Notice of Preparation/Initial Study and Public Comments

Project Title: Sunnyvale East West Channels Flood Protection Project

Notice of Preparation
Draft Environmental Impact Report
Sunnyvale East and West Channel Flood Protection Project
SCH No. 26074002

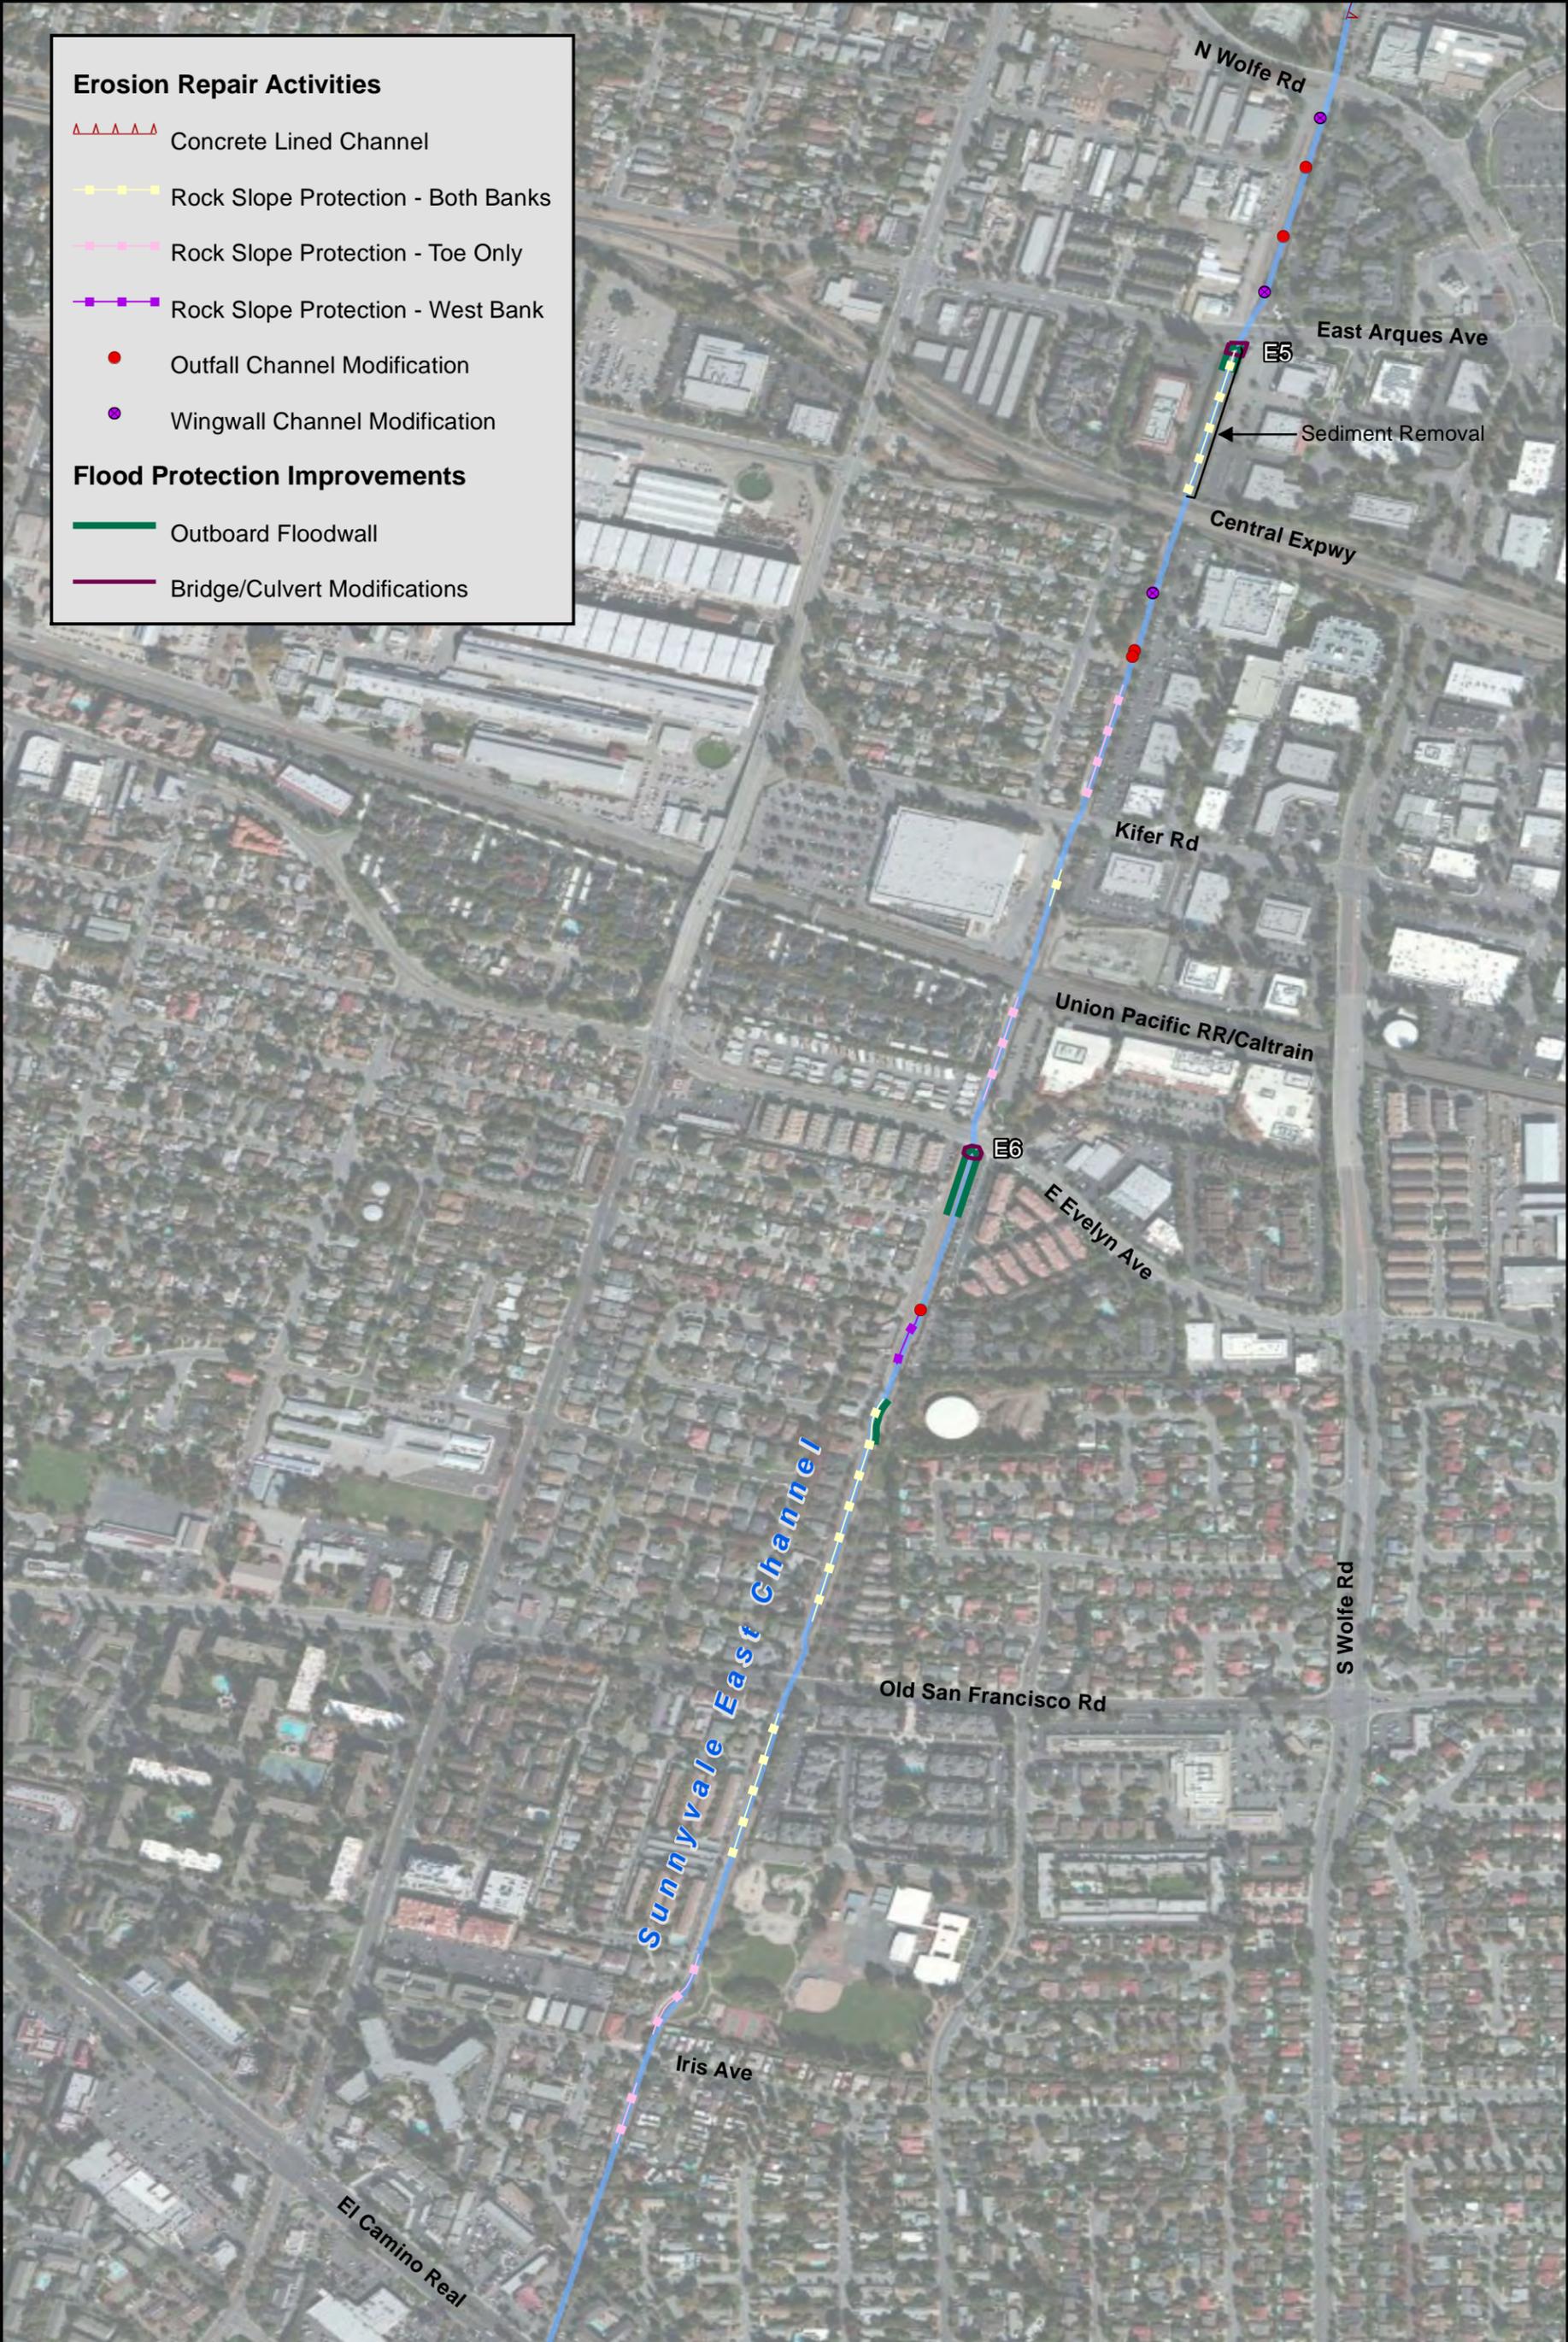
The NOP describes the use of inboard floodwalls, outboard floodwalls, and levee raising for flood control measures. The CEQA document should clearly describe how inboard and outboard floodwalls differ from each other, the different purposes that each type would meet, and the need for both types in this Project. In addition, the CEQA document should address the need for the concurrent use of at least two (but sometimes all three) flood control measures in a few distinct locations (the crossing at Carl Road, and adjacent to Pond A4 in Figure 3A; the crossings at East Caribbean Drive and Moffett Park Drive in Figure 3C; and the crossings at Persian Drive and Tasman Drive, and at the southern end of the floodwall on Sunnyvale East Channel in Figure 3D).
